Historic Preservation Board

- i. Preliminary Review of Alterations; 20 MORNING STREET; Elizabeth Zeeuw & Brian Dunn, Applicant(s). Plan Number: HPBR-002982-2024.

TO: Chair O'Brien and Members of the Historic Preservation Board
FROM: Evan R. Schueckler, Historic Preservation Program Manager
DATE: June 28, 2024
RE: 20 Morning Street – FIRST WORKSHOP – Alterations
PROJECT ID: HPBR-002982-2024
MEETING: July 3, 2024

Figure 3: 1896 (left) and 1909 (right) Sanborn Maps showing the changes in the form of 20 Morning Street.

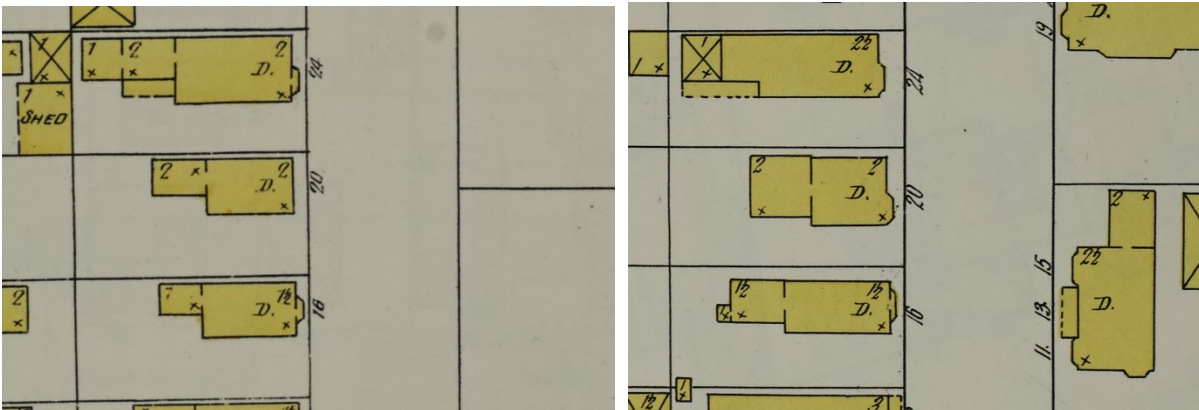
The applicant is proposing to install a new standing seam metal roof. The Sanborn maps show that the roofing was historically wood shingle and later composite (likely asphalt) shingles. In the past, the Board has not been supportive of standing seam metal roofing where not based on a historic precedent; however, the Board could consider whether the roof material is a character-defining feature in this case.

G1 South Elevation
A-2.1 1/4" = 1'-0"

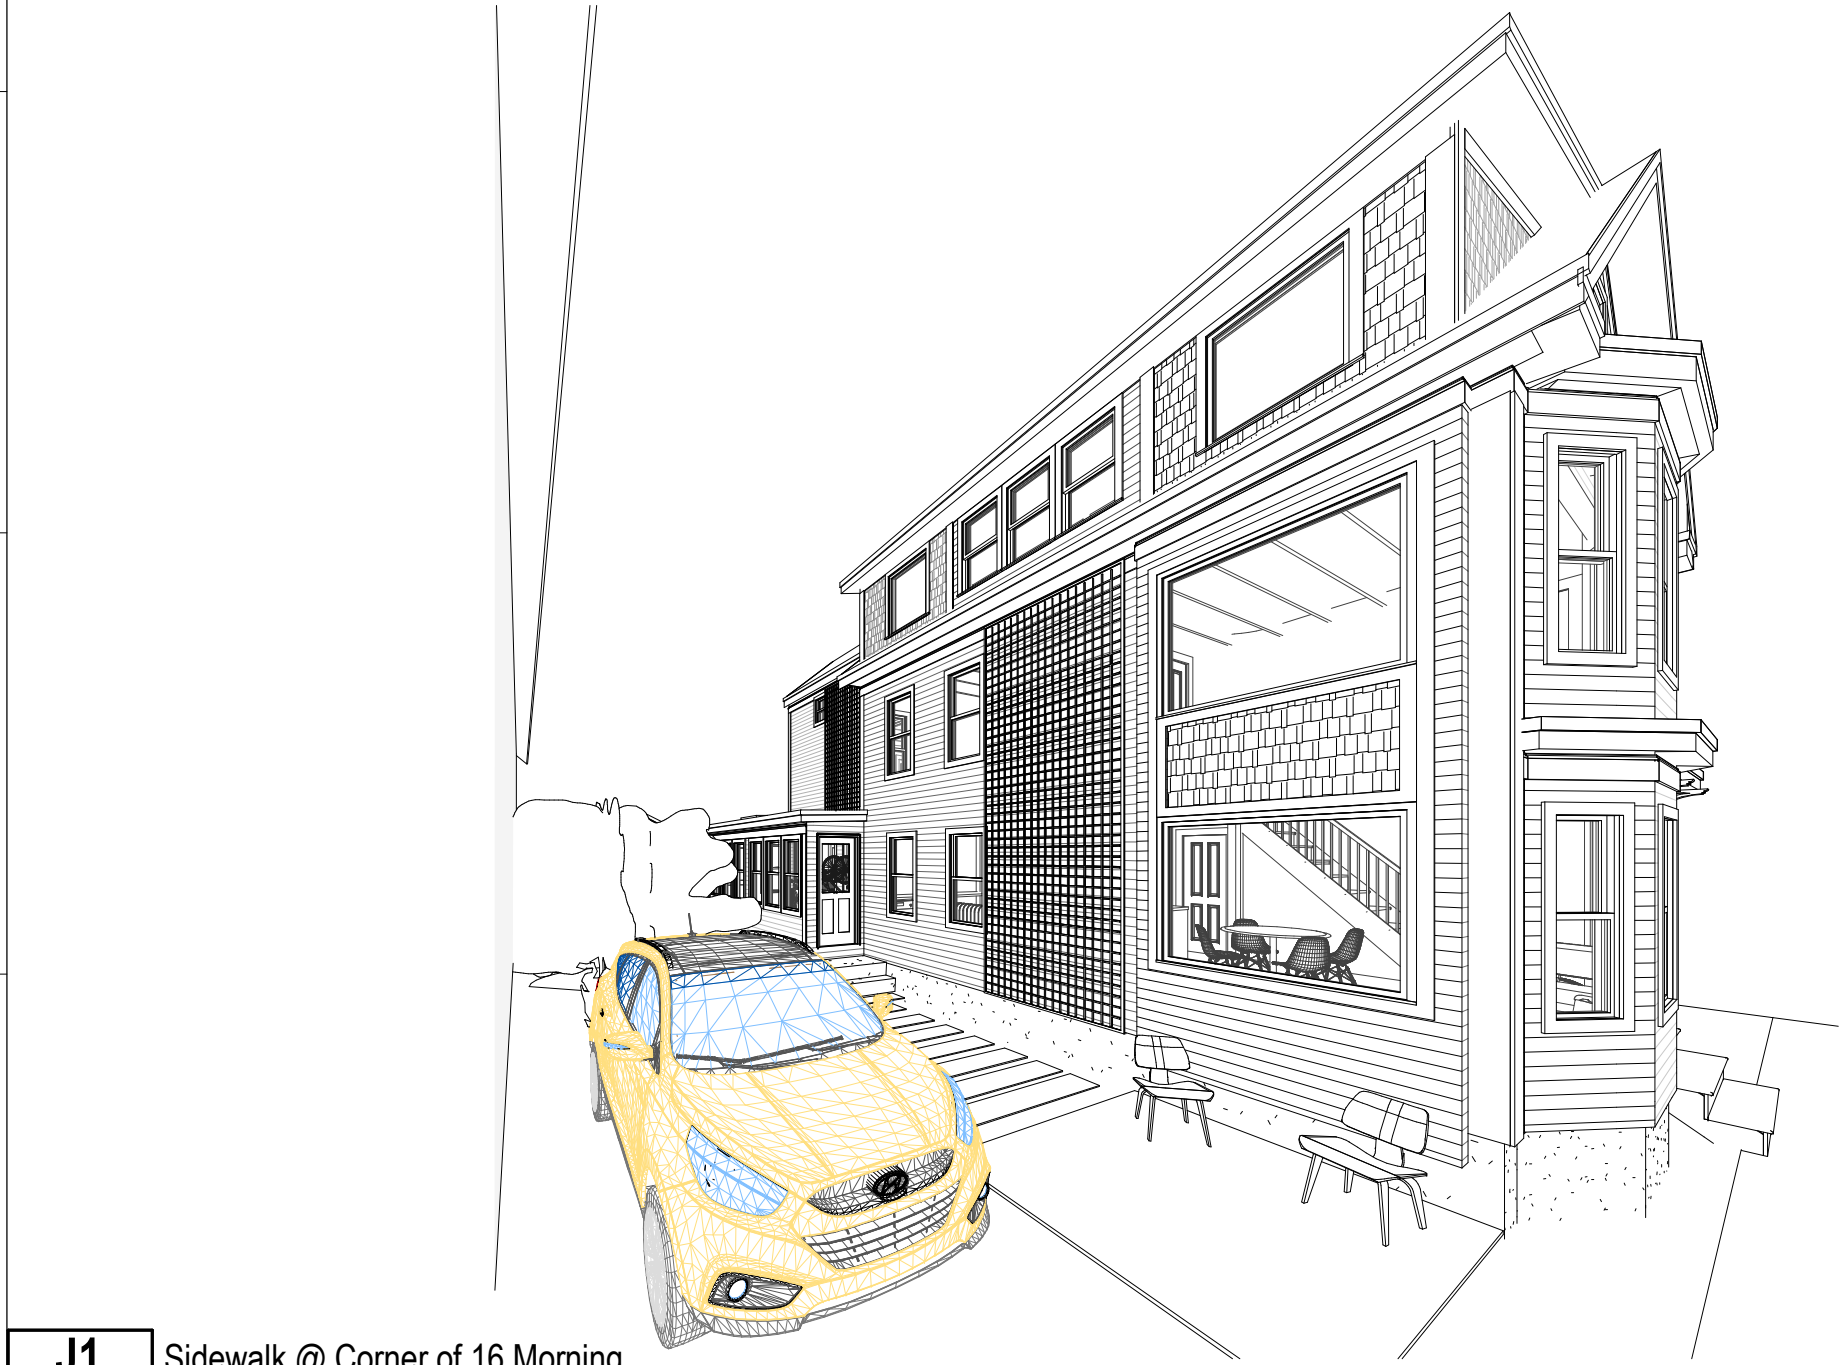
The applicant is also proposing to eliminate two historic window openings on the south elevation and construct a new square bay addition with large picture windows. This addition will be clearly differentiated from the historic elements of the structure through the large picture windows and shingle siding; however, it does require alterations to two historic window openings close to the street. The Board should address the appropriateness of this alteration as a threshold question.

Standard 2	
The distinguishing original qualities or character of a structure, object, or site and its environment shall not be destroyed. The removal or alteration of any historic material or distinctive architectural features should be avoided when possible.	
Standard Met?	Staff Comments
For Board Discussion	The applicant is proposing to completely remove all siding and trim in order to wrap the structure in continuous insulation and new cedar rainscreen siding. The existing siding and some trim are non-historic, having been installed in 2011. The historic eaves and rakes will be removed and recreated to align with the new roof insulation. The applicant is proposing to reinstall as much of the historic trim as possible in the new eave and rake locations. At the front of the building, the applicant is proposing not to install new continuous insulation in an effort to maintain the trim relationships along the street frontage where the building is most visible. Two historic window openings will be eliminated on the south elevation to accommodate the proposed bay addition.

DETAILS
ILLUST.
EXISTING &
PROPOSED
ASSEMBLIES

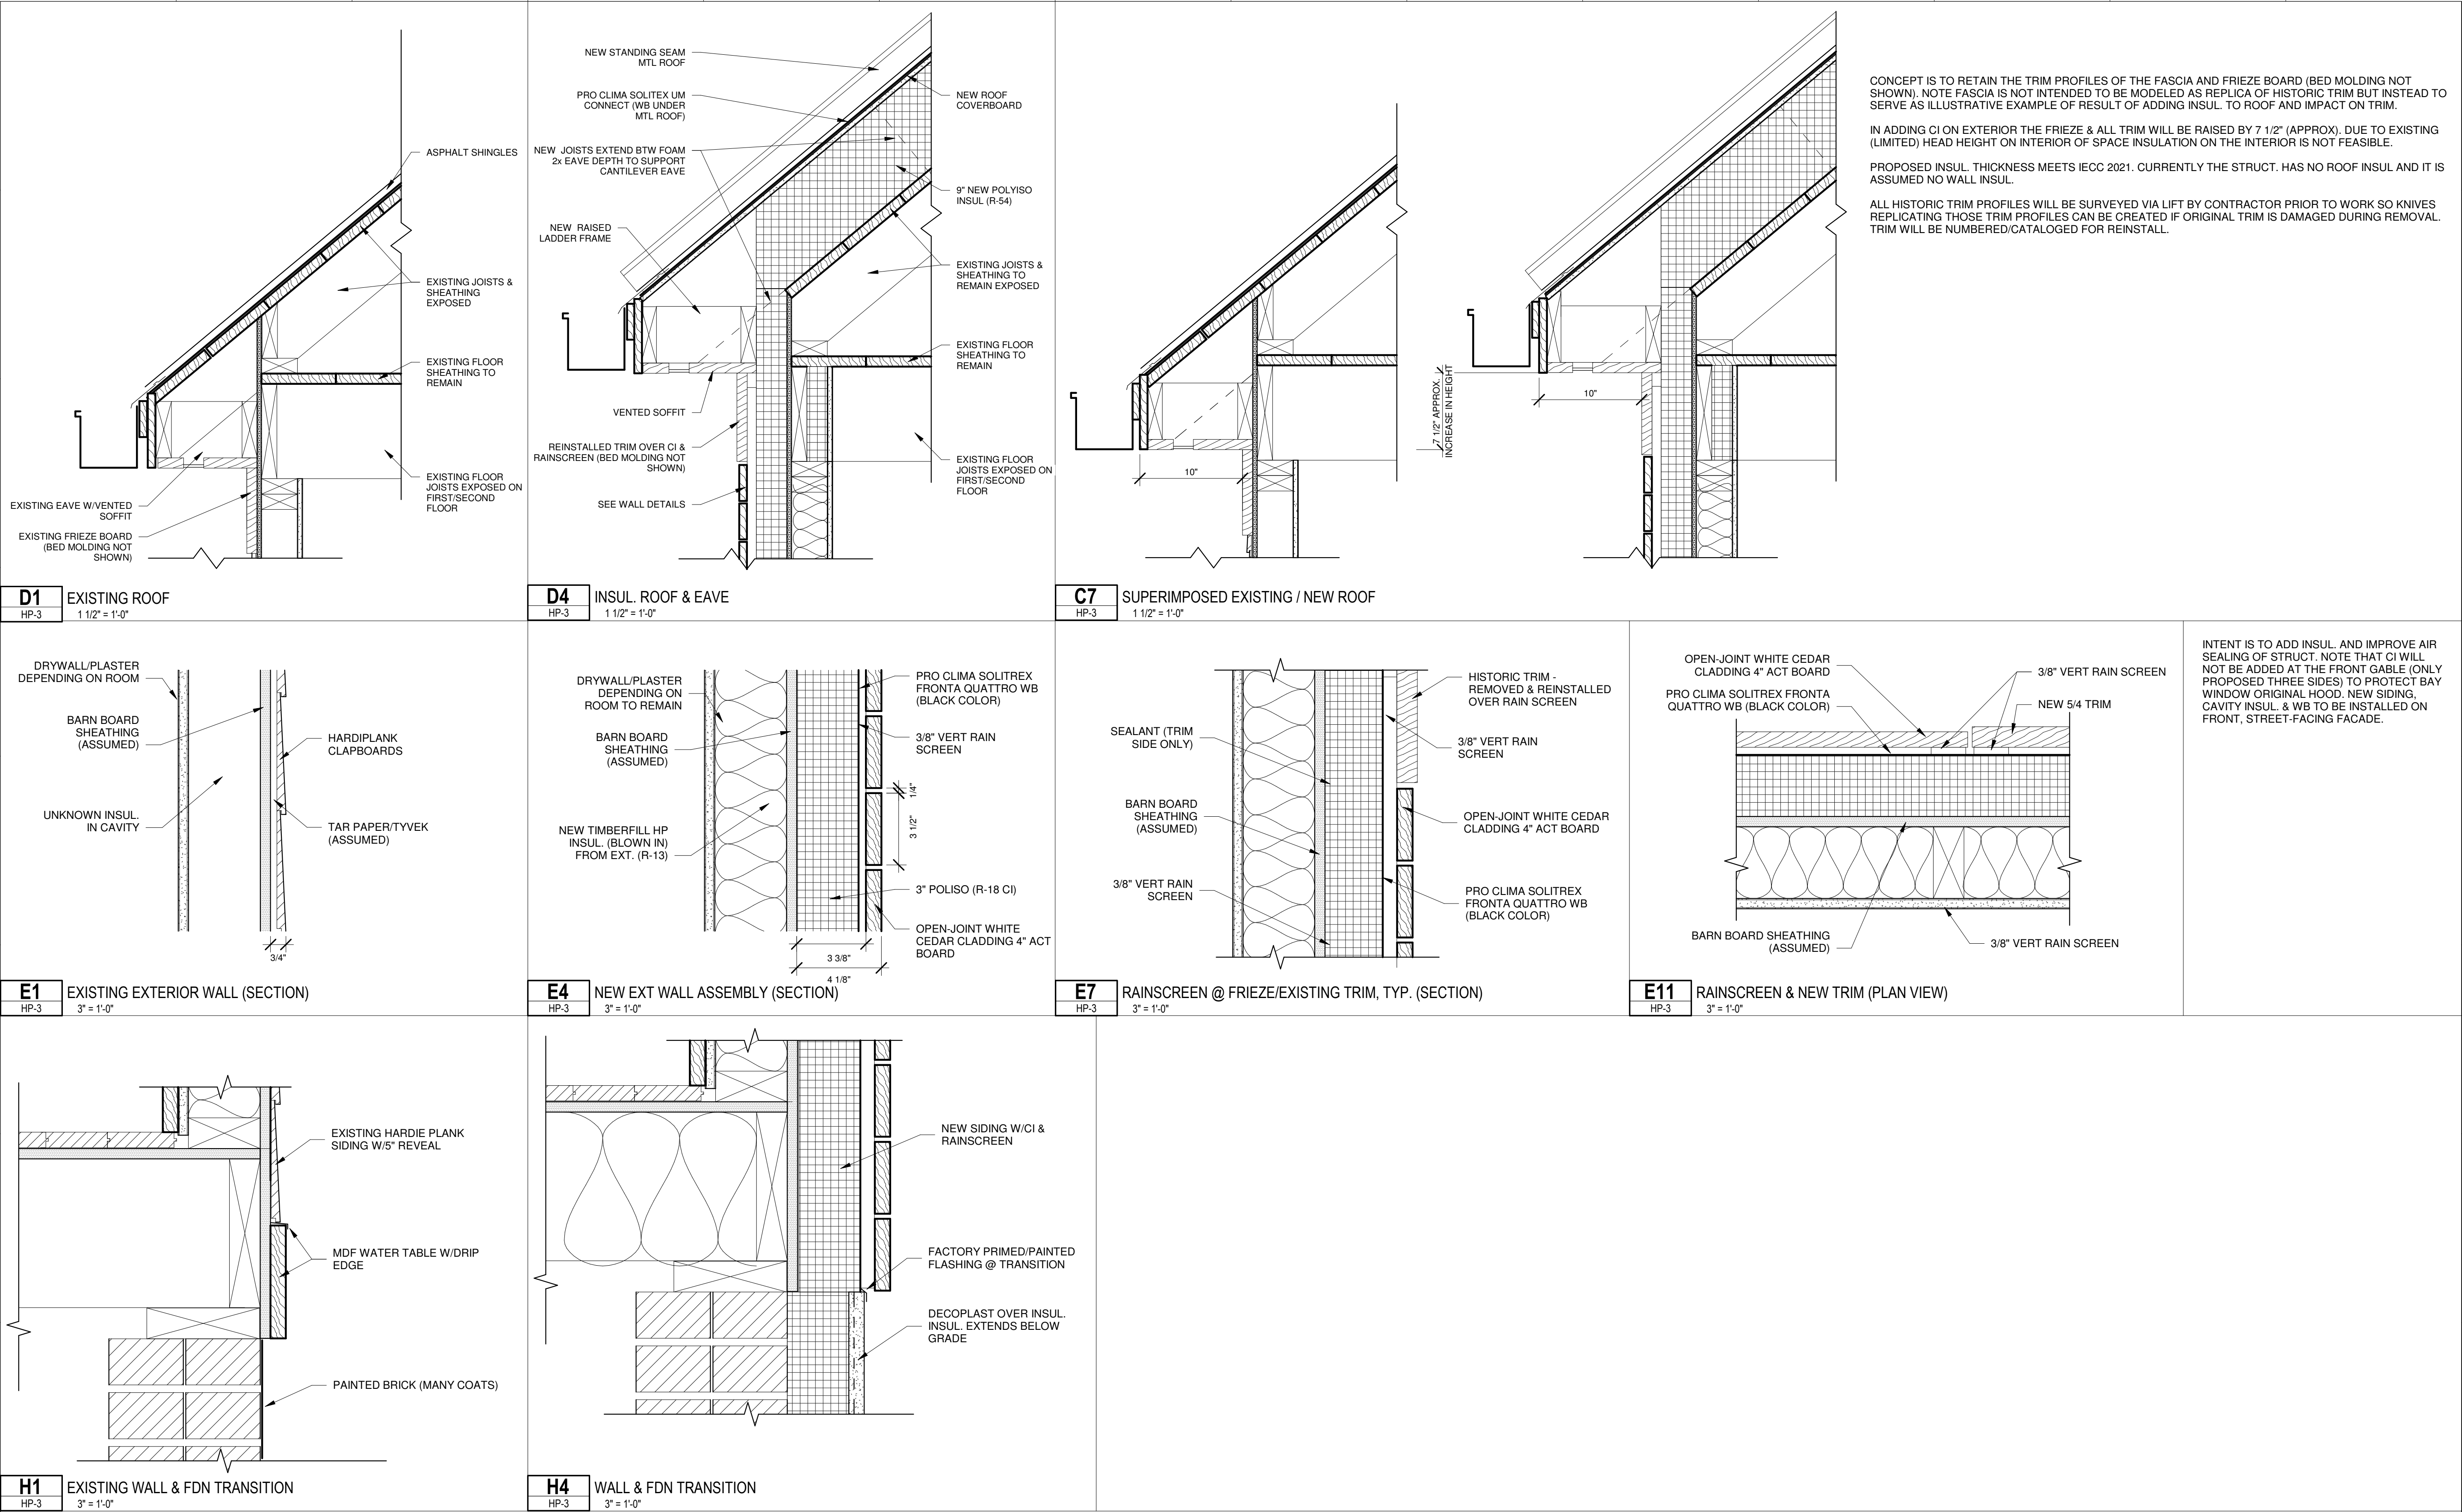
The proposed insulation upgrades will require reconfiguration of a number of exterior details including the eaves, rakes, window surrounds, and corner boards in order to accommodate the added depth (3-3/8" at the walls and 9" at the roof). Staff have encouraged the applicant to study these changes in details so that the Board can review the impact of the proposed changes closely. The applicant has provided several study details that show how they propose to minimize the visual impacts of the changes on the building. For instance, the applicant is not proposing to install additional installation on the street-facing façade in an effort to avoid disrupting the most visible trim details at the two-story bay window and entrance canopy. Staff would encourage the applicant to further study how the changes will be accommodated at the corner boards and to visualize how the relationship between the second story bay cornice and the eave trim will be affected by the proposed additional height. The Board should provide clear guidance on whether

the proposed volume of added insulation is appropriate as a threshold question. If the Board finds that the proposed approach could be appropriate, the Board should provide clear direction on what additional details or information are necessary to complete review.

Standard 5	
Distinctive features, finishes, and construction techniques or examples of skilled craftsmanship which characterize a structure, object, or site shall be treated with sensitivity.	
Standard Met?	Staff Comments
For Board Discussion	The existing eaves and projecting rakes will be removed and recreated to align with the new roof insulation. The applicant is proposing to reinstall as much of the historic trim as possible in the new eave and rake locations. At the front of the building, the applicant is proposing not to install new continuous insulation in an effort to maintain the trim relationships along the street frontage where the building is most visible.
